MICHIGAN STATE UNIVERSITY

TITLE OF PROJECT: Library North Plaza Revitalization

PROJECT NUMBER: CP25058

ADDENDUM NO: 1

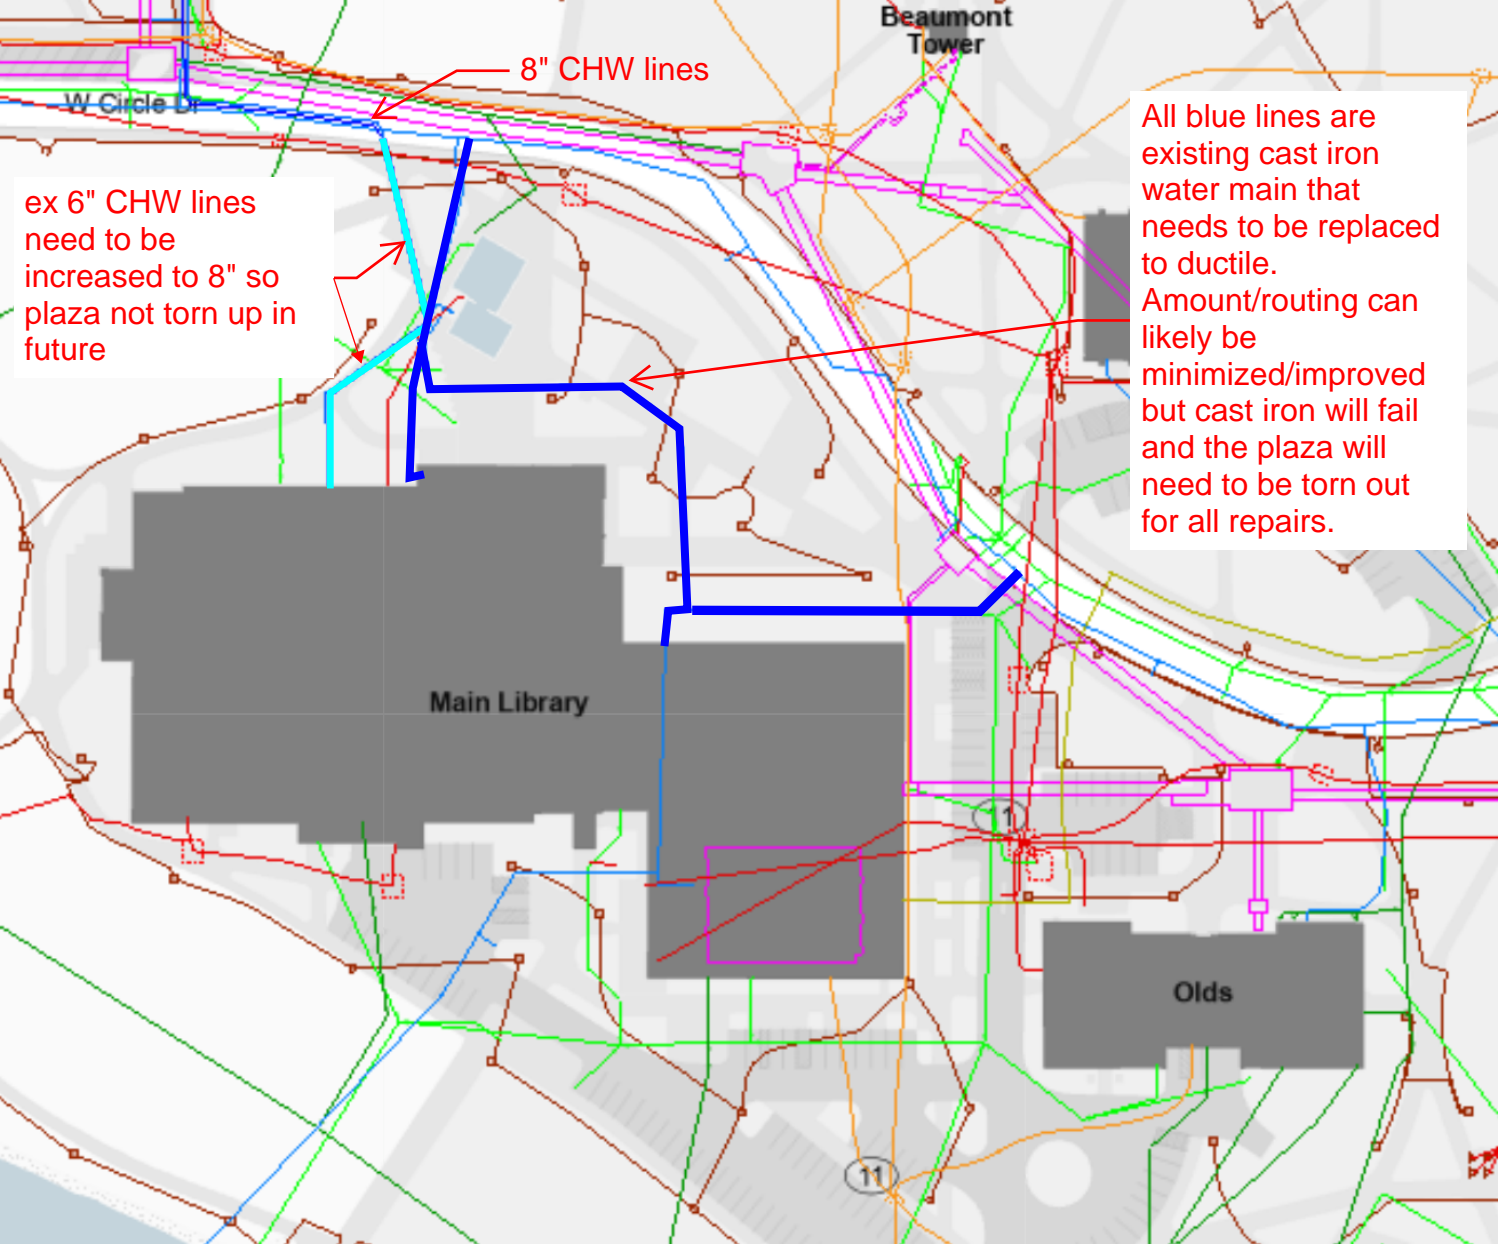
7. Are other utility leads or systems being upgraded as part of the project (water, sanitary, chilled water/steam, fire protection, telecom...) and of so, is the design part of this scope, or by others? The RFP notes electrical, snowmelt, and storm sewer to be included.

8" CHW lines

ex 6" CHW lines
need to be
increased to 8" so
plaza not torn up in
future

All blue lines are
existing cast iron
water main that
needs to be replaced
to ductile.
Amount/routing can
likely be
minimized/improved
but cast iron will fail
and the plaza will
need to be torn out
for all repairs.

Response: See attached plan. chilled water and domestic water lines require replacement. This element will be part of this project. The funding for this portion is in discussion.
